Certificate of Appropriateness Case Report

Hearing Date: March 17, 2010
Filing Date: September 24, 2009
Case No.: **2009.0901A**
Project Address: **679-685 3rd Street**
Historic District: South End Historic District
Zoning: SLI (Service/Light Industrial)
50-X Height and Bulk District
Block/Lot: 3788/015
Applicant: Marc Dimalanta
D-Scheme Studio
1488 Harrison Street, Suite 204
San Francisco, CA 94103
Staff Contact Pilar LaValley - (415) 575-9084
pilar.lavalley@sfgov.org
Reviewed By Tina Tam – (415) 558-6325
tina.tam@sfgov.org

Historic Preservation Commission Draft Motion

EXISTING AND PROPOSED
GROUND FLOOR PLANS
AND EXTERIOR ELEVATIONS

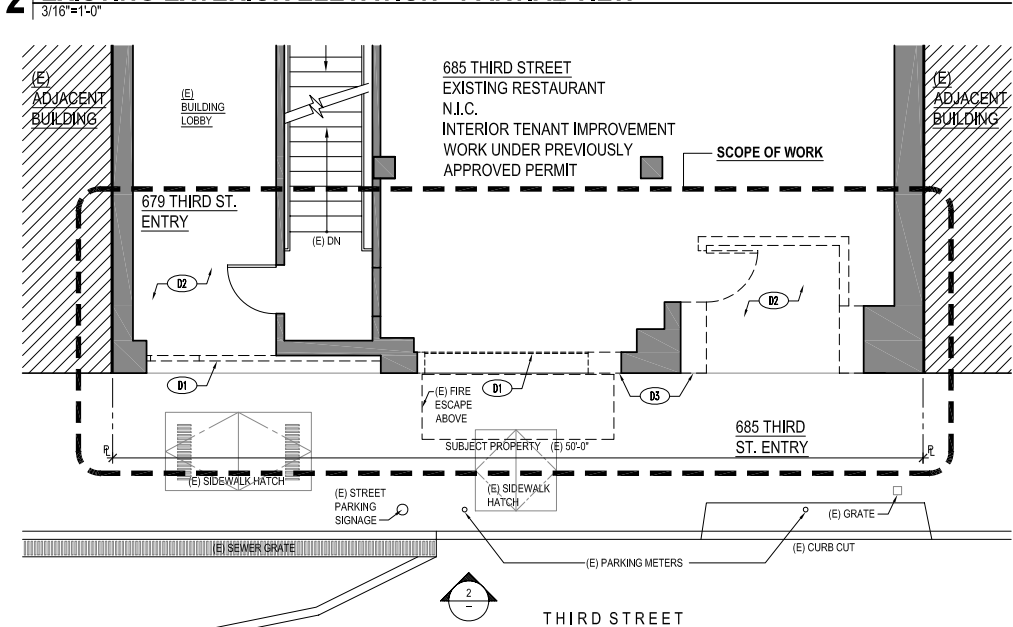
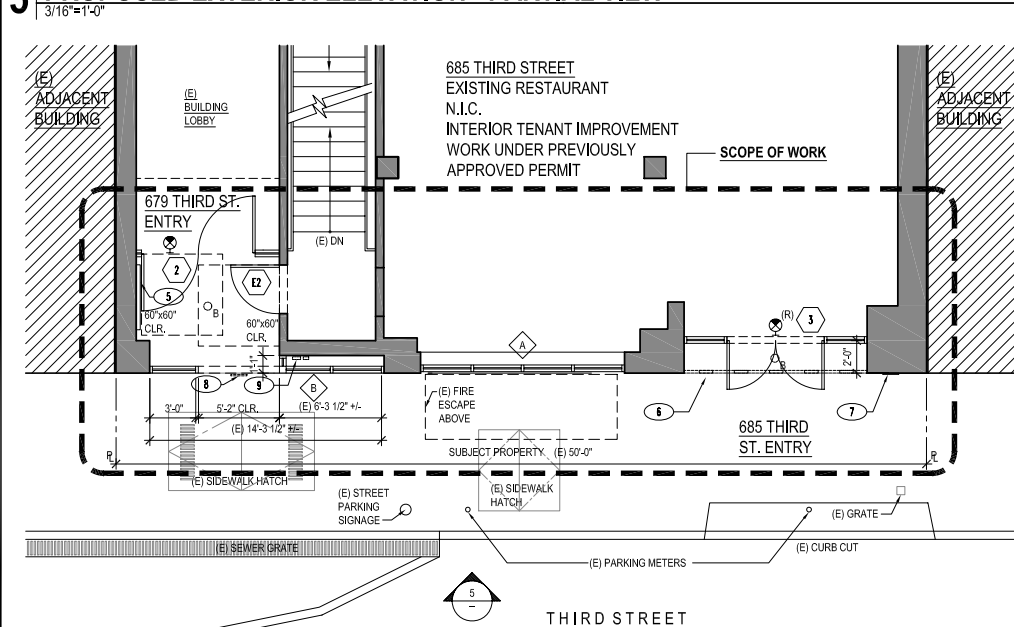
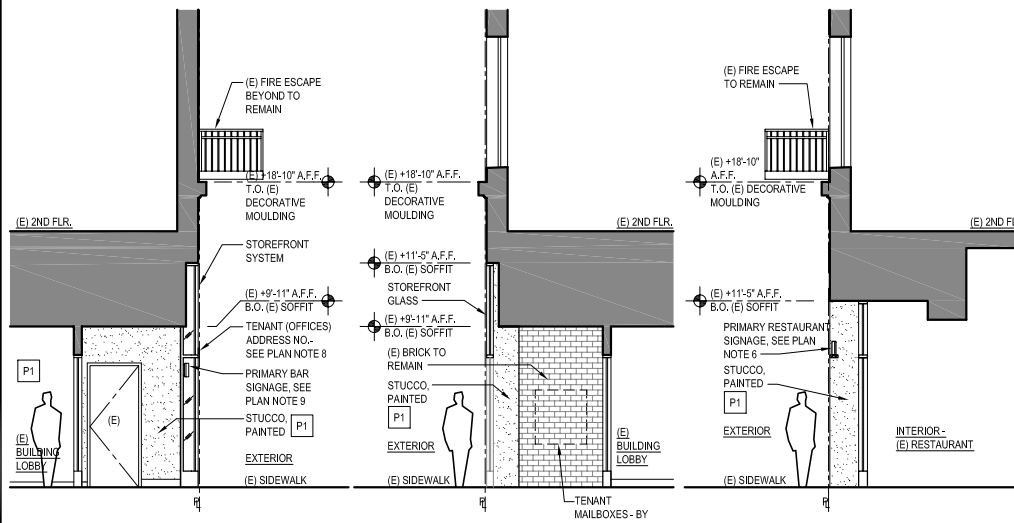
Proposed work would occur within the three ground floor bays on the front façade. The northern bay (main building entrance) currently contains temporary plywood infill. Behind infill, an enclosed stair and dropped ceiling partially obstructs the original opening; these interior alterations were constructed without Planning Department approval and without benefit of a Certificate of Appropriateness. At the center and southern bay, the original size and shape of the openings has been partially infilled with plywood and drywall. This work was also done without Planning Department approval and without benefit of a Certificate of Appropriateness. Previous work undertaken without benefit of a Certificate of Appropriateness does not appear to have impacted historic fabric as photographic documentation indicates that the ground floor openings had non-historic, aluminum storefront systems. The proposed

work would provide storefront openings for a new restaurant tenant space in center and southern bay and new storefront for the main building entrance at northern bay. Work would remove previously installed infill in two of the openings and make the configuration of the third opening (main entrance) more compatible with the character of the district.

Staff finds that removal of contemporary infill and installation of new aluminum sash window and new aluminum and glass storefront system will not detract from the historic character of the property and will not cause any significant removal or alteration of historic materials, spaces, or features which characterize the property. The new aluminum storefront system for the restaurant entrance will have a medium bronze finish and will be slightly inset to allow for the swing of the doors. The aluminum sash window will also have a medium bronze finish and fixed sash. Stainless steel, back-lit letters mounted to a rail spanning the width of the opening will provide signage at the restaurant entrance.

Staff finds that the removal of contemporary infill and installation of a new storefront system is compatible with the building and district. The enclosed stair and dropped ceiling, which partially obstructs the original opening, will be retained and the new storefront installed at the building face in a manner that is consistent with storefronts throughout the district. Translucent glazing at the transom will partially obscure the dropped ceiling and stair while maintaining transparency at the street and restoring, at least in a visual sense, the historic size and shape of the ground floor opening. In order to provide code-complying exiting, the center panel of the new storefront will be open. Behind this opening, a vestibule will lead to the lobby entrance and stair entrance. While this sort of “mock” storefront approach is not ideal, it seems a reasonable application in this particular case where there is no existing original storefront or evidence of original storefront configuration and where no historic material appears to have been removed for installation of the enclosed stair and dropped ceiling. In this particular case, the proposed “mock” storefront system will restore the configuration of the ground floor bays at the street and partially obscure the stair and ceiling infill in a manner that is compatible with the building and district, will not impact historic features or fabric, will preserve features or spaces that characterize the building, and will be reversible. Stainless steel, back-lit letters installed in the face of the stair wall behind the new storefront glazing will provide signage for the upstairs bar tenant.

Staff finds that incorporation of new, back-lit, primary tenant signs within the new storefronts in the northern and southern bays conforms to the requirements outlined in Section 6 of Appendix I.
